Dominion Nuclear Connecticut, Inc.
Millstone Power Station
Rope Ferry Road
Waterford, CT 06385

Docket No. 50-336
B18634

Millstone Nuclear Power Station, Unit No. 2
License Basis Document Change Request 2-5-00
Boration, Emergency Core Cooling, Containment Spray and Cooling
and Auxiliary Feedwater Systems

FIGURE 3.1-1

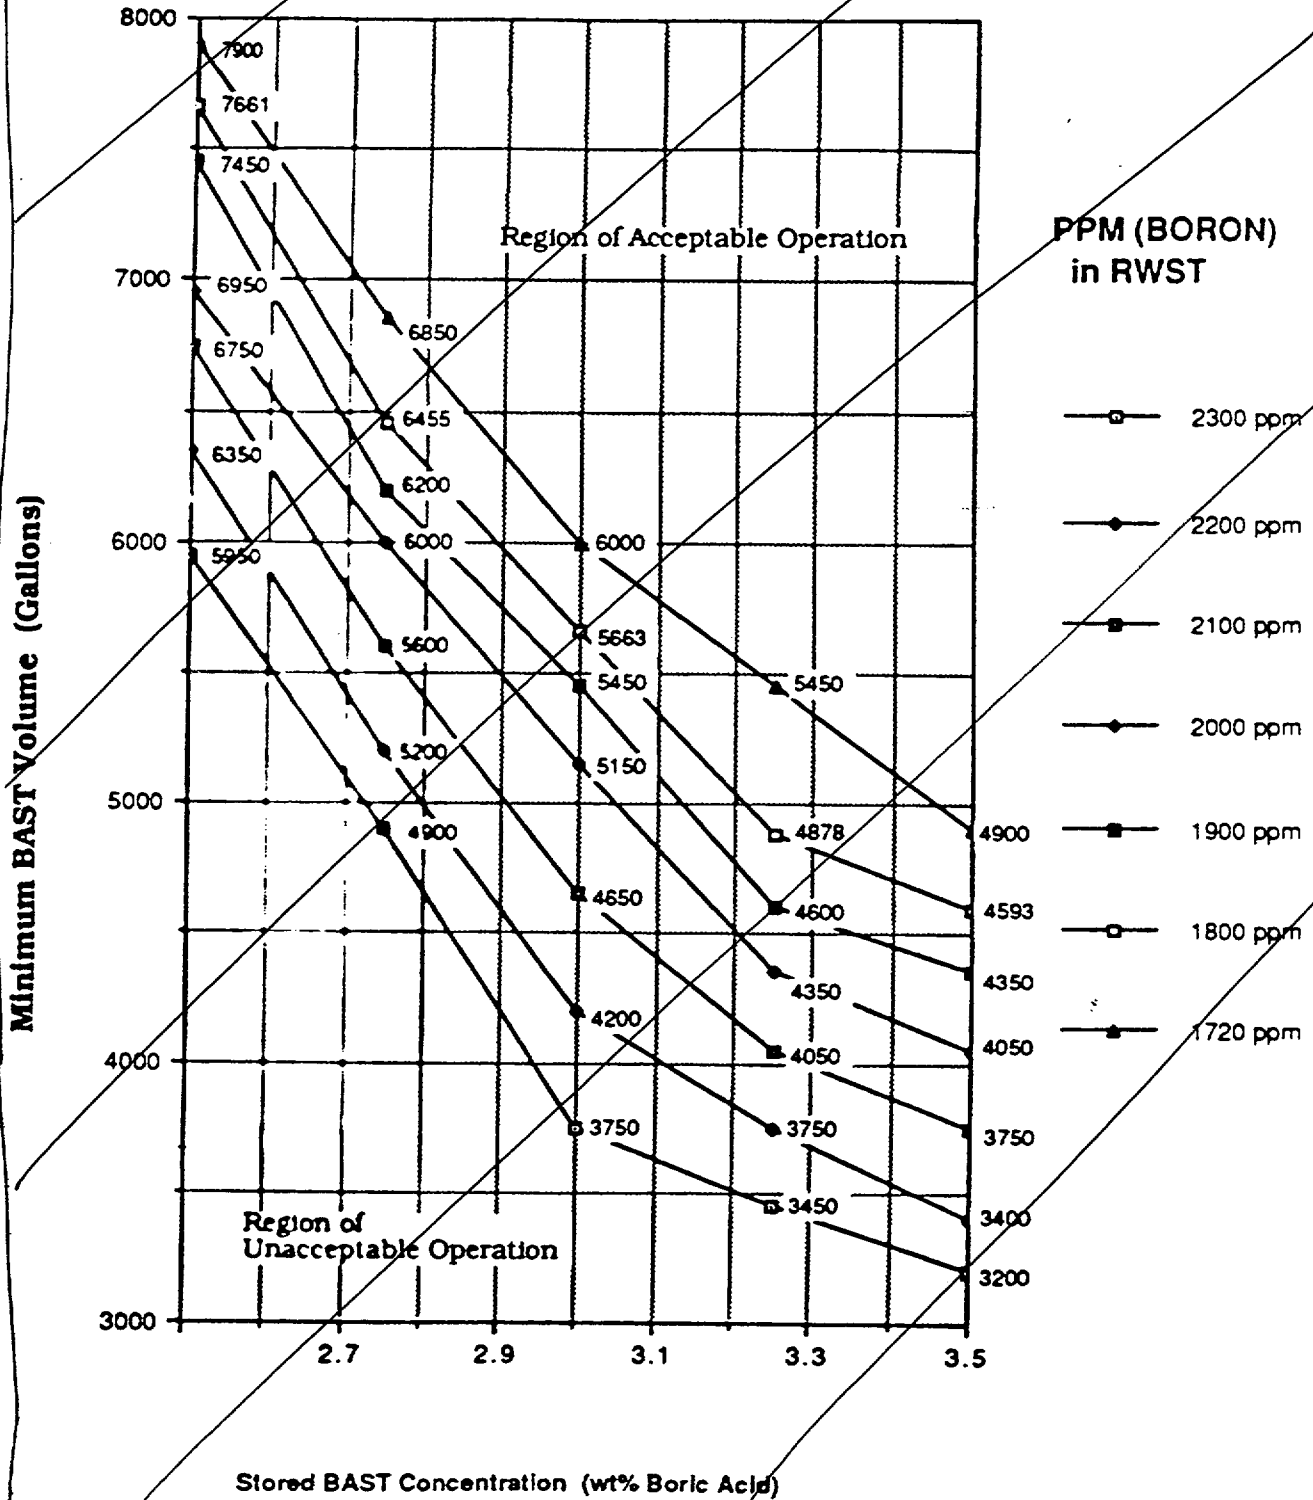
The requirements of Technical Specifications 3.1.2.1 through 3.1.2.8, except the boron dilution analysis restriction as previously discussed, will be relocated to the TRM. The requirements contained in these specifications do not meet the criteria contained in 10 CFR 50.36c(2)(ii) for items that must be in Technical Specifications. Refer to the Safety Summary contained in this attachment for a discussion of this criteria. The phrase "This Page Intentionally Left Blank" will be added to Pages 3/4 1-8 through 3/4 1-11 and 3/4 1-13 through 3/4 1-19.

INSERT → This Page Intentionally
Left Blank 3/4 1-17
